City of Irvine
Parks Master Plan
FINAL | JULY 2015

ADA Assessment of Play Areas in Irvine Parks

TECHNICAL SUPPLEMENT

Ages 5-12 Play Area

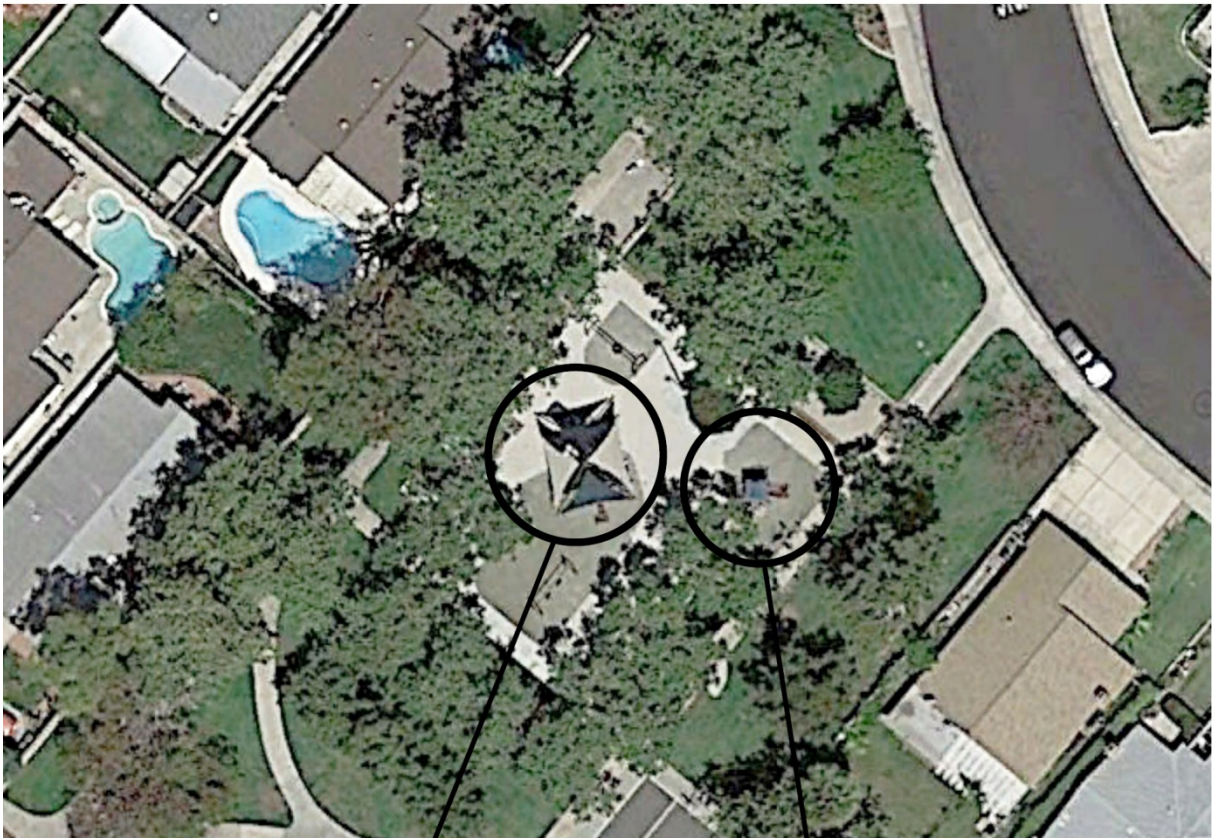
Action	Action Note	Planning Cost Estimate	Relevant Code
Improve or evaluate play area surface	Further evaluation of fall attenuation surface is recommended.	\$0	CBC 11B-1008.2.6.1 ADA 1008.2.6.1 ADA 1008.2.6.2
Install tread striping	Striping is not provided on stairs connecting play components.	\$200	CBC 11B-210.1 CBC 11B-504.4.1
Modify play component	A 30 by 48 inch minimum clear space with a slope of 2.0 percent maximum is not provided at the spinner seat or horizontal ladder due to sand surface.	\$800	CBC 11B-1008.4.2 ADA 1008.4.2
Provide an accessible path of travel	An accessible route is not provided to the horizontal ladder or spinner seats due to sand surface. The horizontal ladder is 57 inches off the path of travel and the spinner seat is nine inches off the path of travel. There is a 3/4 inch gap between the concrete walk and the play area curb (1/2 inch maximum is allowed).	\$200	CBC 11B-206.2.17 CBC 11B-206.2.17.1 CBC 11B-303.2 CBC 11B-1008.2 ADA 206.2.17 ADA 303.2 ADA 1008.2

Woodbury Park: Ages 2 to 5 Play Equipment Area

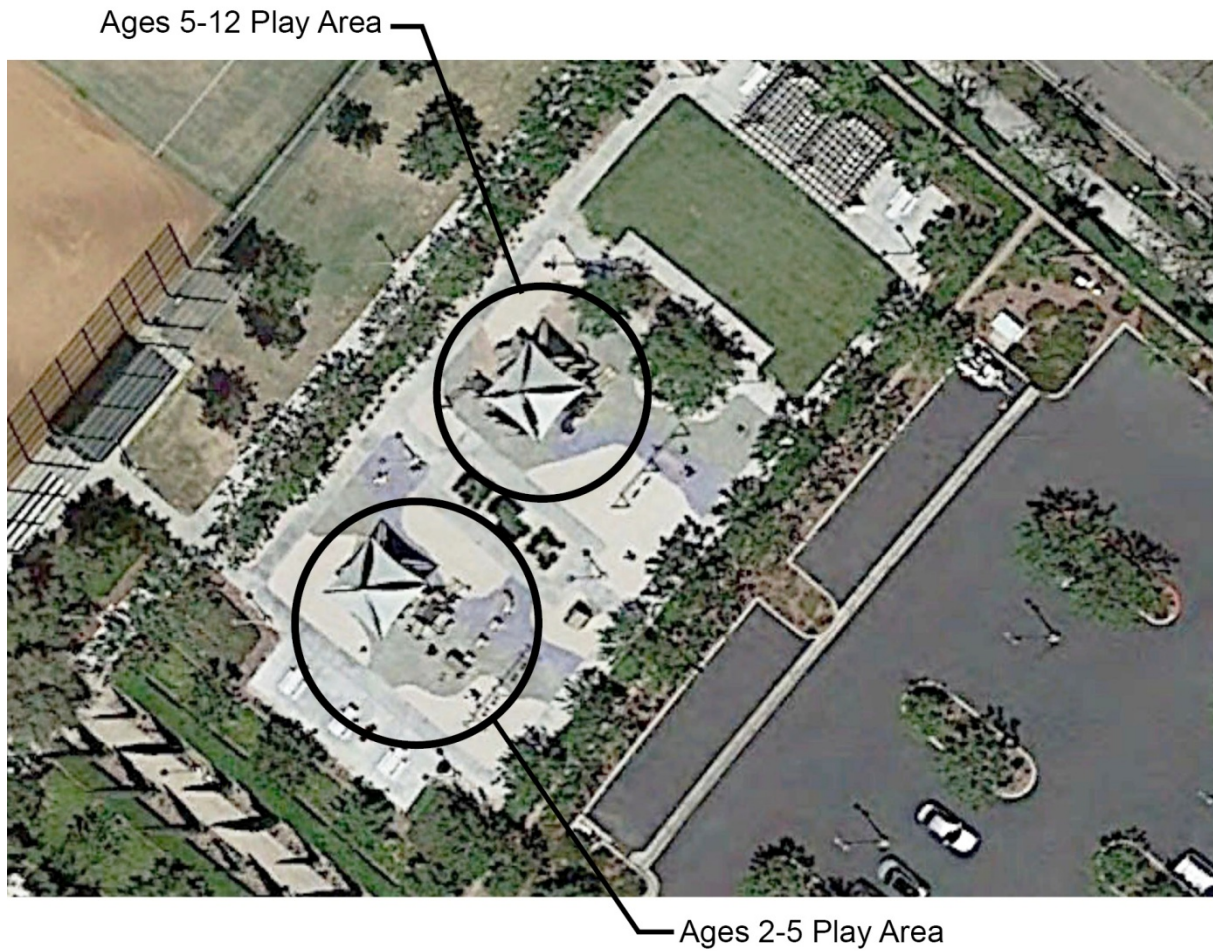
Action	Action Note	Planning Cost Estimate	Relevant Code
Improve or evaluate play area surface	Further evaluation of fall attenuation surface is recommended. Worn top layer particularly at climber component.	\$0	CBC 11B-1008.2.6.1 ADA 1008.2.6.1 ADA 1008.2.6.2
Install or modify transfer system	The 30 by 48 inch ground space adjacent to transfer platform has a slope of up to 3.0 percent (2.0 percent maximum is allowed).	\$400	CBC 11B-1008.3.1.3 ADA 1008.3.1.3
Install tread striping	Striping is not provided on stairs connecting play components.	\$200	CBC 11B-210.1 CBC 11B-504.4.1
Modify play component	A 30 by 48 inch minimum clear space with a slope of 2.0 percent maximum is not provided at each ground level play component. Slope is up to 3.1 percent at spring toy, 3.4 percent at sand table, and 3.3 percent at swings.	\$1,200	CBC 11B-1008.4.2 ADA 1008.4.2
Provide play components	Knee space at play table is 18-5/8 inches high and 22 inches wide between benches (knee clearance shall be 24 inches high minimum and 30 inches wide minimum for tables not set up for parallel approach). The table is not positioned to allow for a parallel approach. Table is 12 inches behind front of benches.	\$5,000	CBC 11B-1008.4.3 ADA 1008.4.3
